To: T10 Technical Committee
 From: Rob Elliott, Compaq Computer Corporation (Robert.Elliott@compaq.com)
 Date: 18 July 2001
 Subject: SAM-2, SPC-3, SPI-4, SBC-2 WAKEUP and reset cleanup

Suggested changes to SPI-4, SAM-2, SBC-2, and SPC-2 follow.

Figure 2 – SCSI power conditions flow control (automatic switching)

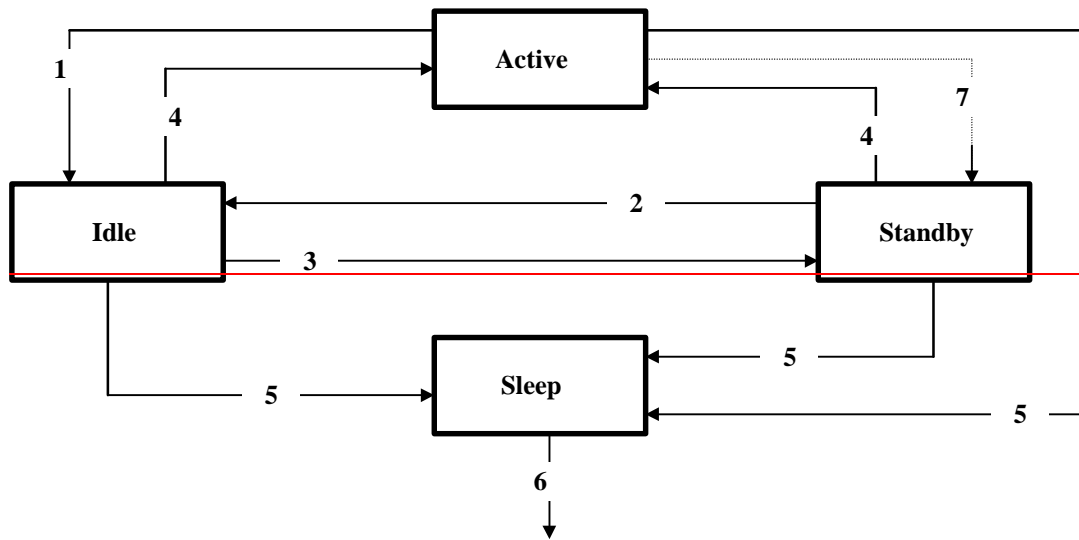
~~4.2.1.5 Power conditions~~

Path 6: A WAKEUP task management function returns the device to the state defined by the saved power mode page parameters.

Figure 3 – SCSI power conditions flow control (controlled switching)

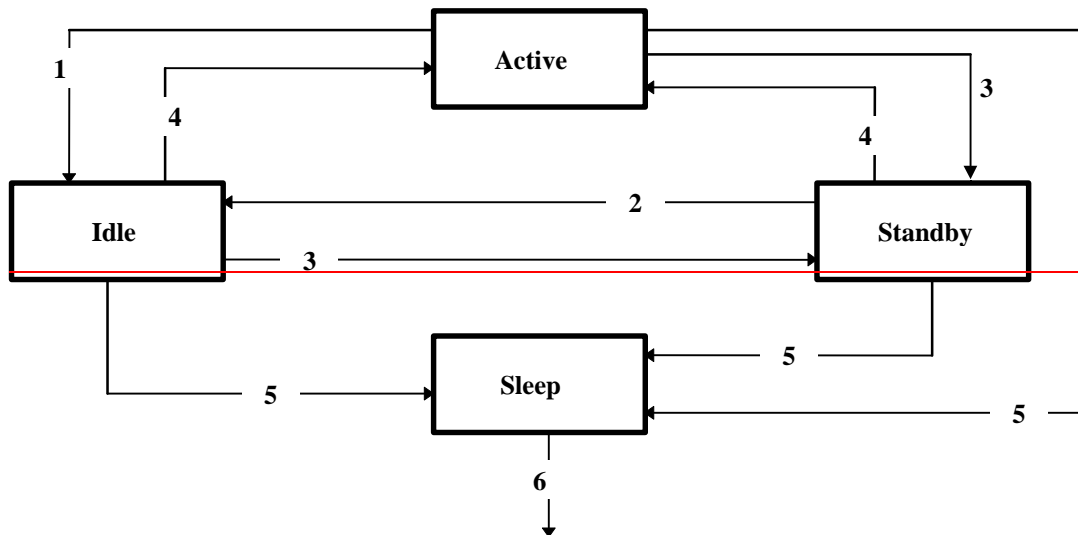
Path 6: A WAKEUP task management function returns the device to the state defined by the saved power mode parameters.

Figure 2 - Power condition transitions (automatic switching)

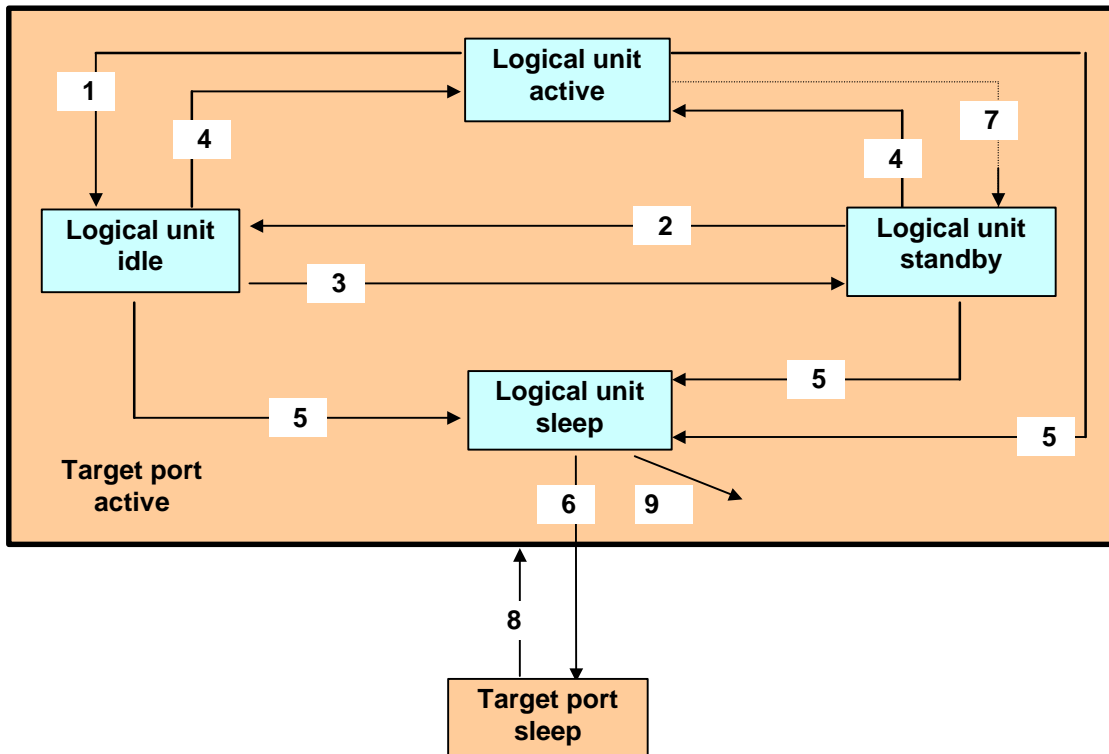
[Move SBC-2 section 4.2.1.5 modeling power conditions here. Due to extensive changes, change bars are not included.]

- Path 5: A START STOP UNIT command with a power condition code of 5h.
- Path 6: When all logical units in a target port reach the logical unit sleep power condition, the target port transitions to the target port sleep power condition.

- Path 7: A standby time-out when the idle bit is set to zero.
- Path 8: A wakeup or hard reset returns the target port to the active power condition and returns each logical unit to the power condition (active, idle, or standby) defined by the saved power condition mode page parameters.

- Path 9: A wakeup or hard reset returns the logical unit to the power condition (active, idle, or standby) defined by the saved power condition mode page parameters.

Figure 2 - Power condition transitions (controlled switching)

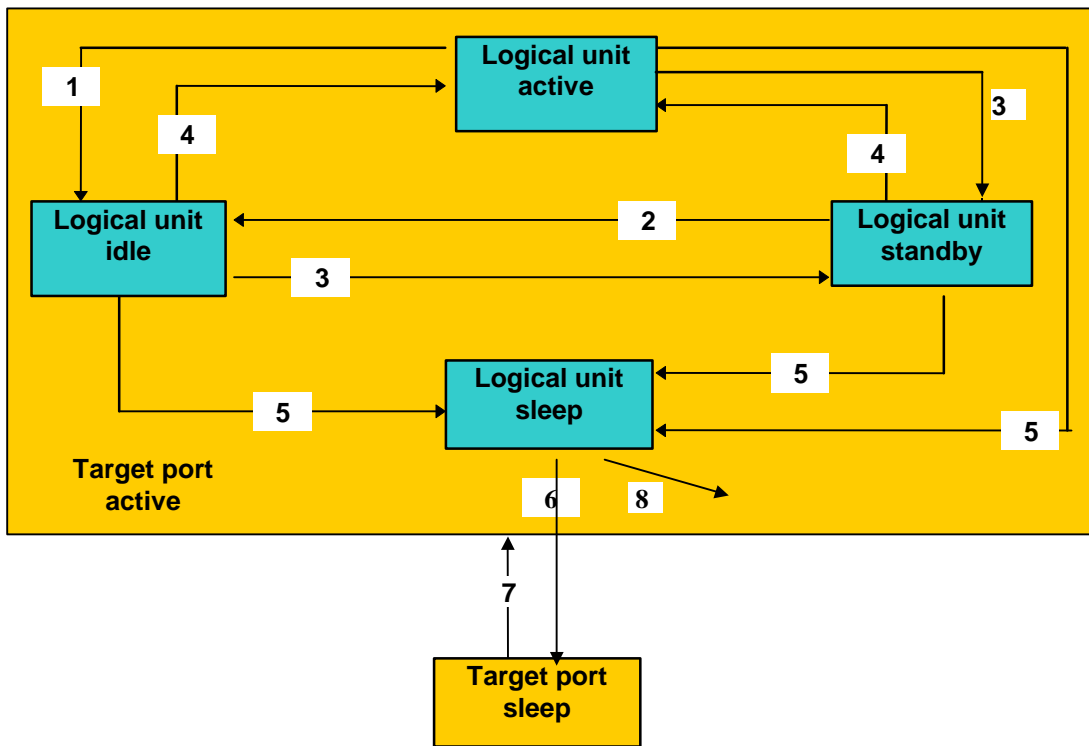
- Path 4: A START STOP UNIT command with a power condition code of 1h.
- Path 5: A START STOP UNIT command with a power condition code of 5h.
- Path 6: When all logical units to which a target port has access reach the logical unit sleep power condition, the target port transitions to the target port sleep power condition.

- Path 7: A wakeup or hard reset returns the target port to the active power condition and returns each logical unit to the power condition (active, idle, or standby) defined by the saved power condition mode page parameters.

- Path 8: A wakeup or hard reset returns each logical unit to the power condition (active, idle, or standby) defined by the saved power condition mode page parameters.
